BLUE SPRINGS MEADOW
EL PASO COUNTY
CONSTRUCTION DRAWINGS
AUGUST 2026

CONSTRUCTION DRAWINGS
COVER SHEET

CONSTRUCTION DRAWINGS
GRADING & EROSION CONTROL
INITIAL PHASE

CHANNEL SECTION SWALE DP3A

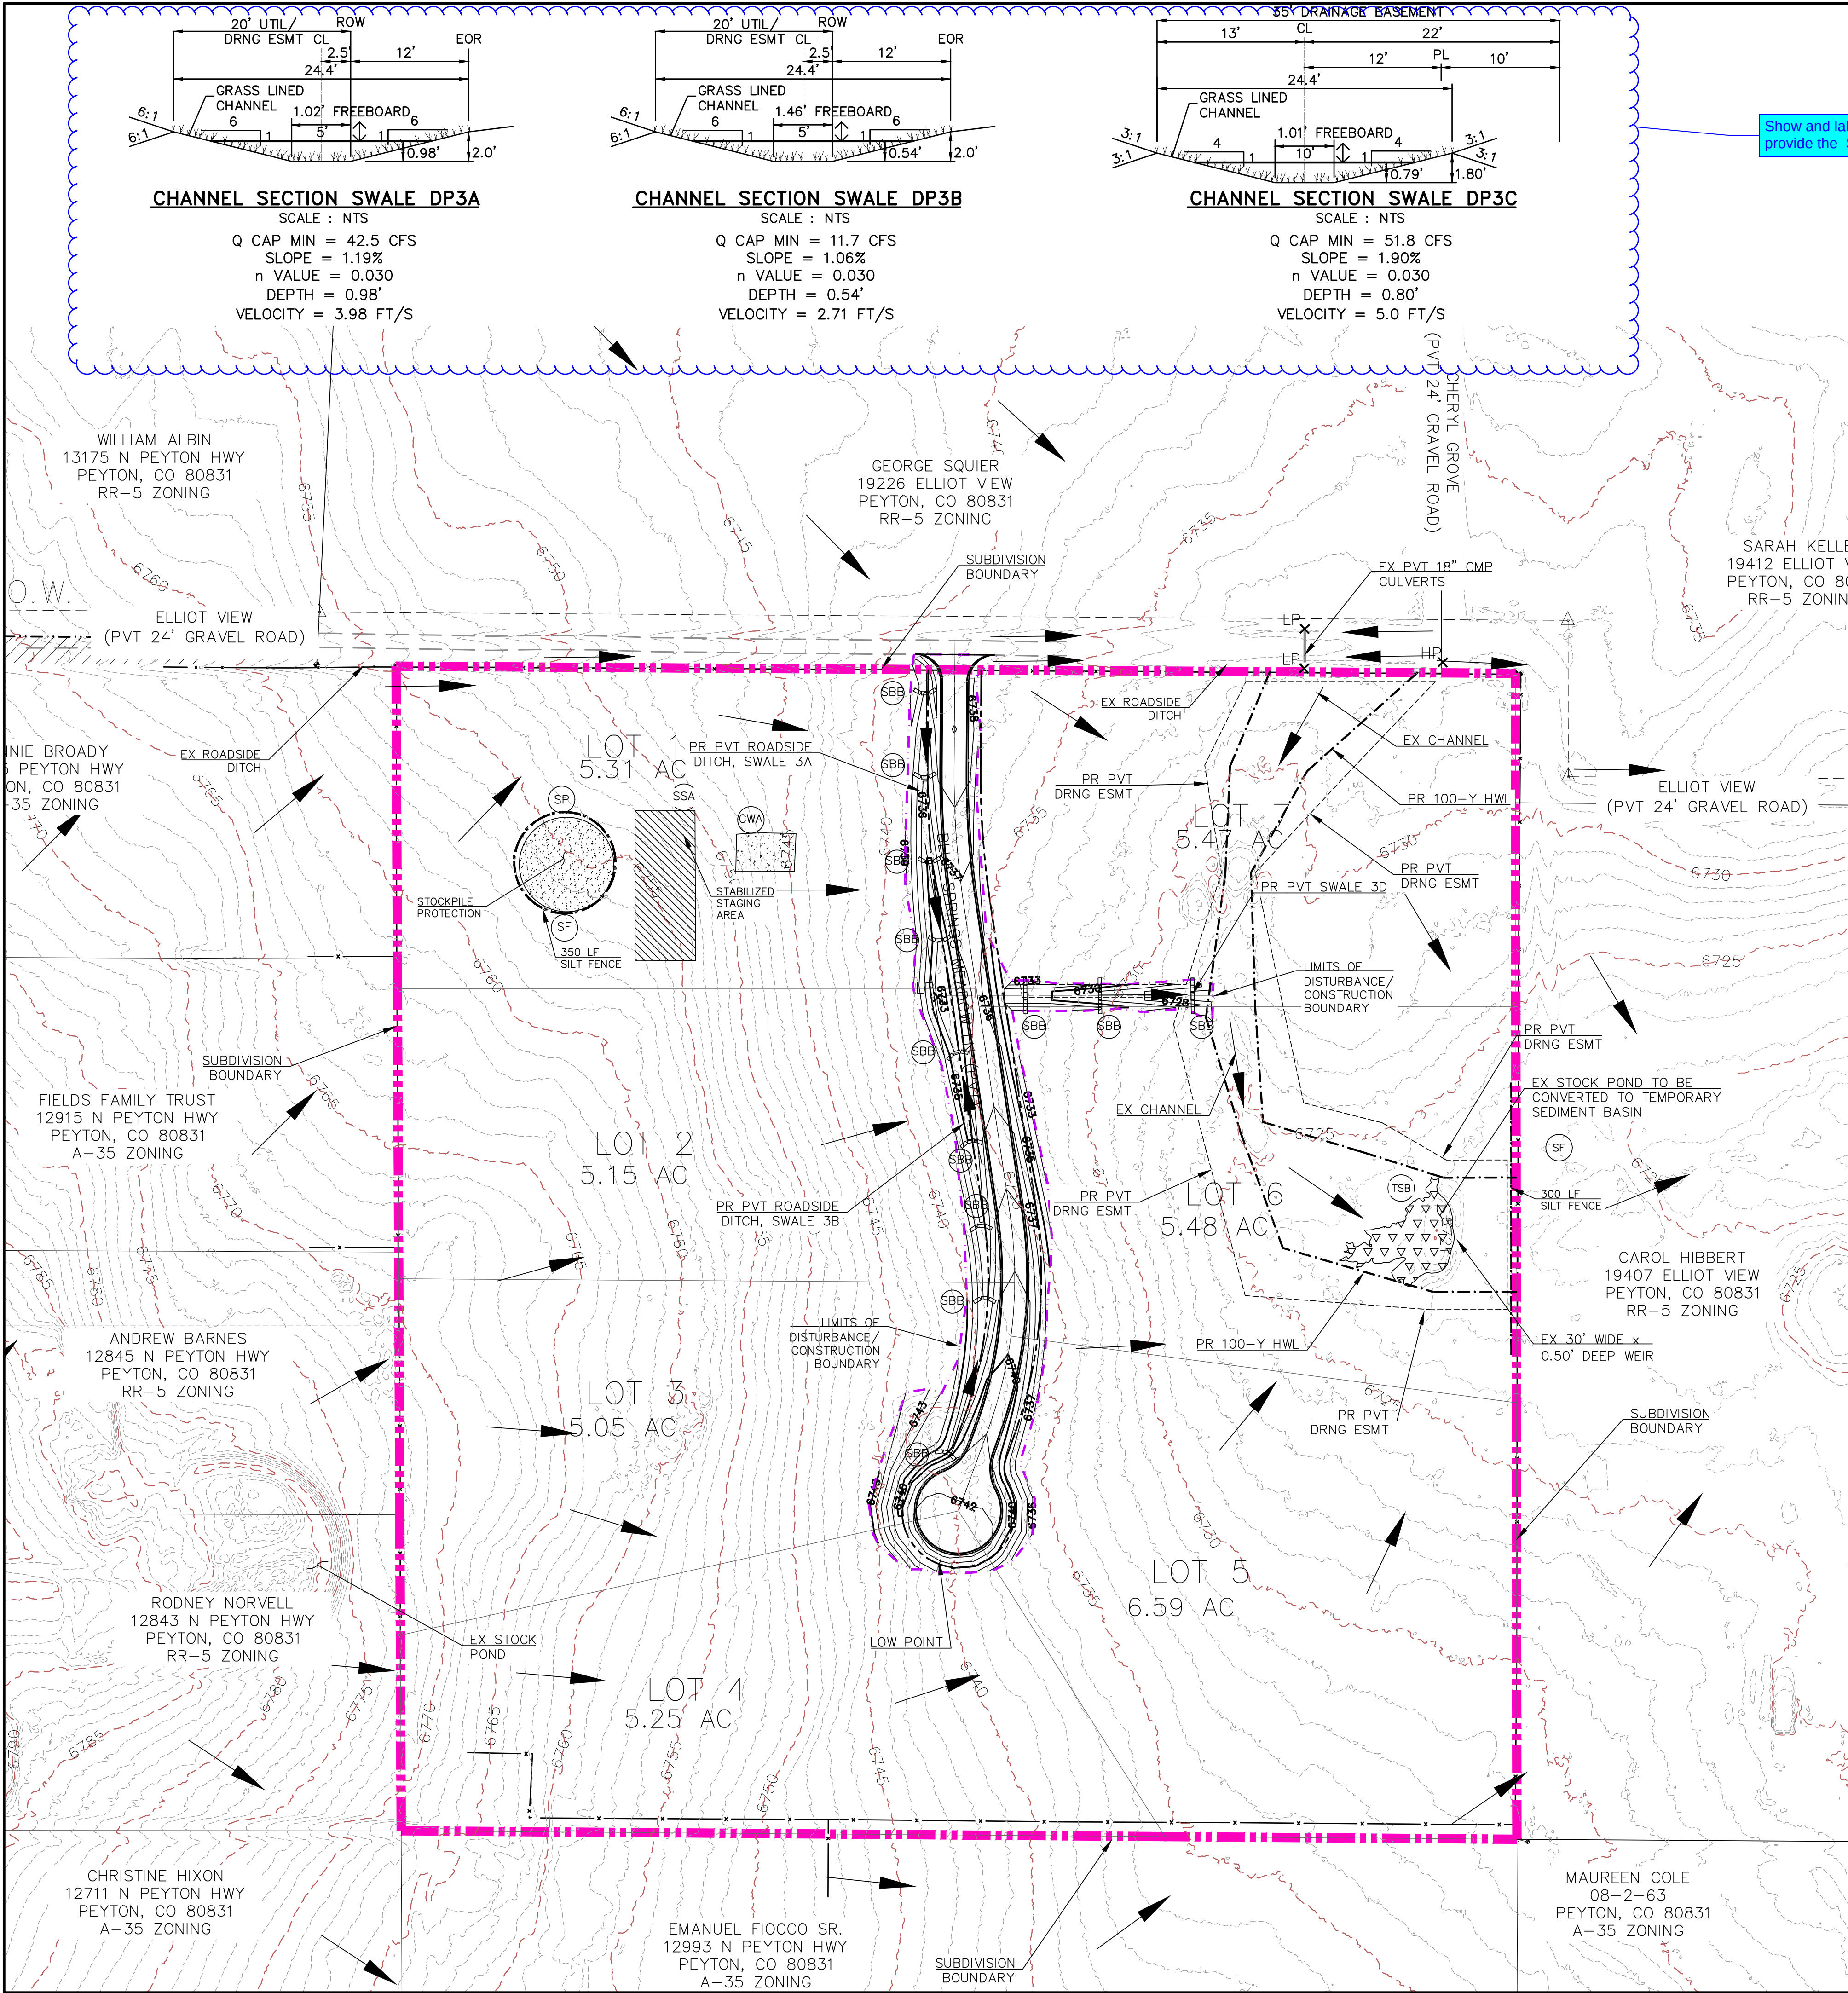
Show and label the CL alignment for the channels and provide the STA. limits for each channel section swale.
